[Note: Replace 80.2.9 as follows and renumber the subsequent subclause numbers appropriately.]

80.3 Service Interface specification method and notation

Figure 80–1—40GBASE-R and 100GBASE-R Inter-sublayer Service Interfaces

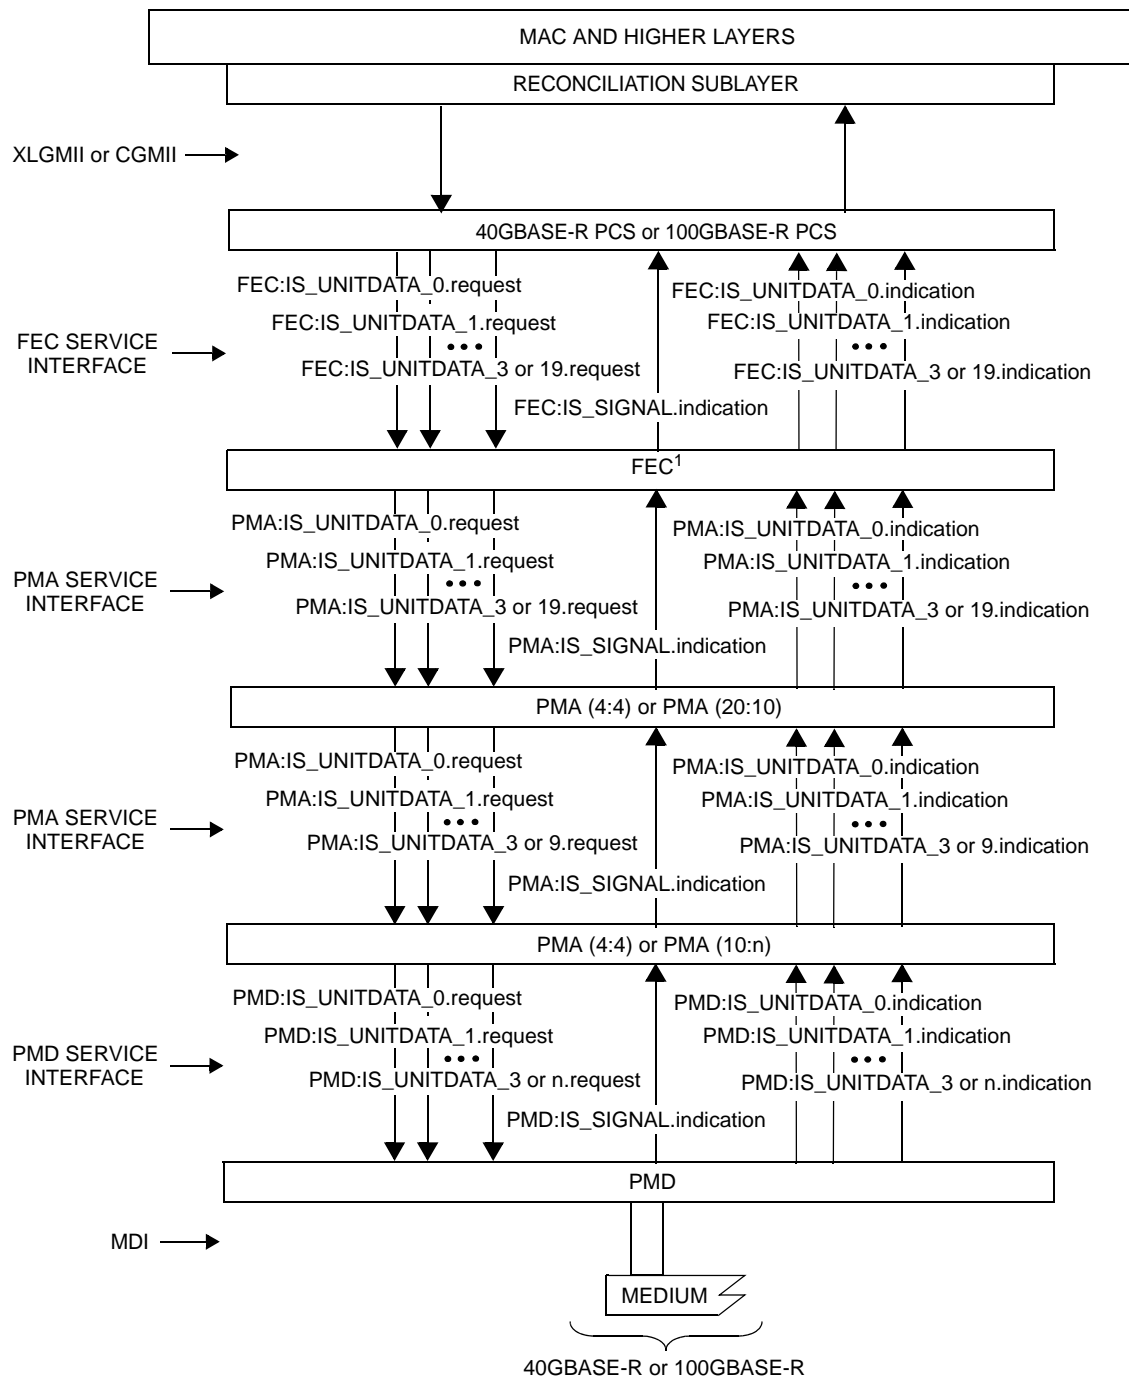
An example of inter-sublayer interfaces for 40GBASE-R and 100GBASE-R with their corresponding instance names are illustrated in Figure 80–1. For example, the primitives for one instance of the inter-sublayer service interface, named the PMD service interface, are identified as PMD:IS_UNITDATA_x.request, PMD:IS_UNITDATA_x.indication, and PMD:IS_SIGNAL.indication. Primitives for other instances, of inter-sublayer interfaces, are represented in a similar manner as described above.
